FOUNDATION INVESTIGATION REPORT
For
The Proposed Culvert at the Crossing of
Hwy. 403 and Relocated Cooksville Creek
(Bridge #57) Site #24-336
Town of Mississauga, County of Peel
District #6 (Toronto)
W.O. 73-11076 -- W.P. 127-66-48

Re: Hwy. 403 and Cooksville Creek Culvert
W.P. 127-66-48, Site 24-336
District 6, Toronto

We have reviewed the preliminary design drawing (24-336-P1) and would like to submit the following comments.

SUBMD V.N.	CHECKED	WP NO. 127-66-38	DRAWING NO.
DRAWN S.R.	CHECKED	WO NO. 73-11076	73-11076A
DATE NOV. 7, 1973	SITE NO.	BRIDGE DRAWING NO.	
APPROVED	CONT. NO.

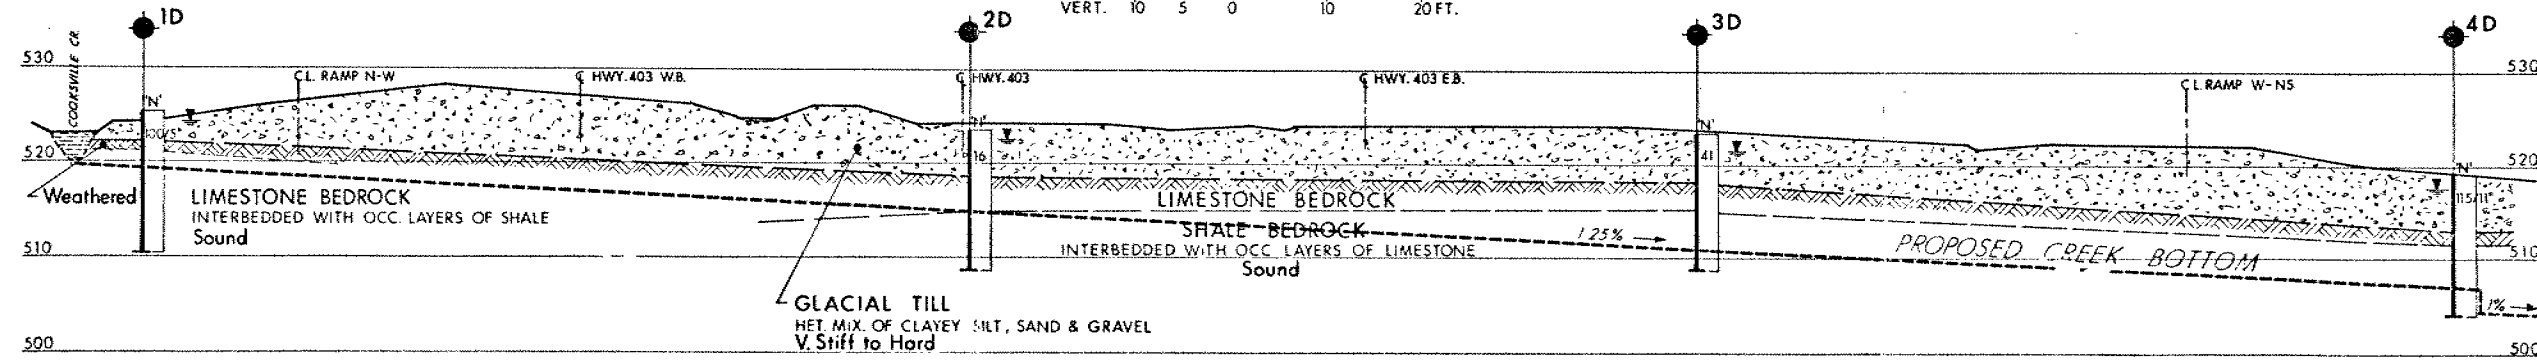
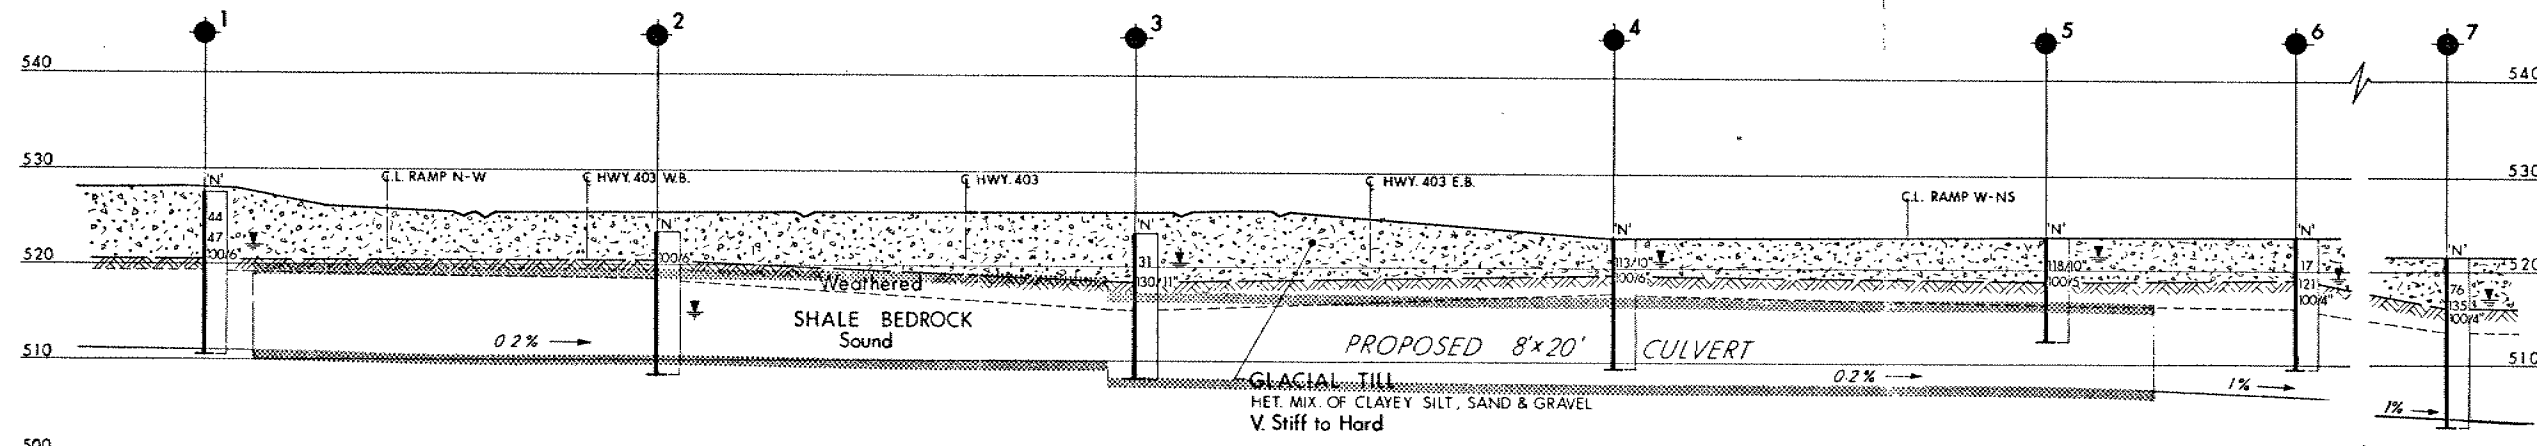
Please advise also what height of fill would be the basis for the culvert design as determined from the Bore Hole Locations and Soil Strata Dwg. 73-11076A contained in the Foundations Report.

- LIST OF DRAWINGS
24-336-1 GENERAL LAYOUT
-2 BORE HOLE LOCATION & SOIL STRATA
-3 CULVERT DETAILS
-4 RETAINING WALLS DETAILS
-5 INLET CHANNEL LINING

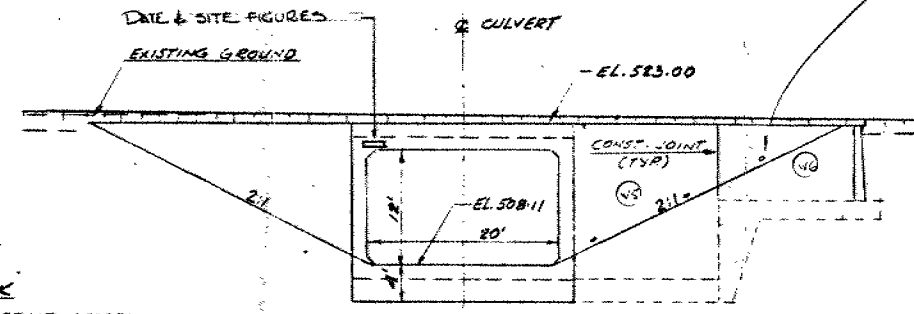
1. A 3" thick mass concrete working slab should be poured within 3 hours after excavation reaches the foundation level in order to prevent the shale from deteriorating upon its exposure to the atmosphere.
2. The box culvert and the adjoining retaining walls should have a granular backfill. This backfill should be composed of granular 'A' and should be 4 feet thick for the retaining walls and 2 feet thick for the box culvert. The purpose of this backfill is to provide drainage for the retained rockmass, as well as to serve as a cushion for absorbing the lateral stresses released by the bedrock.
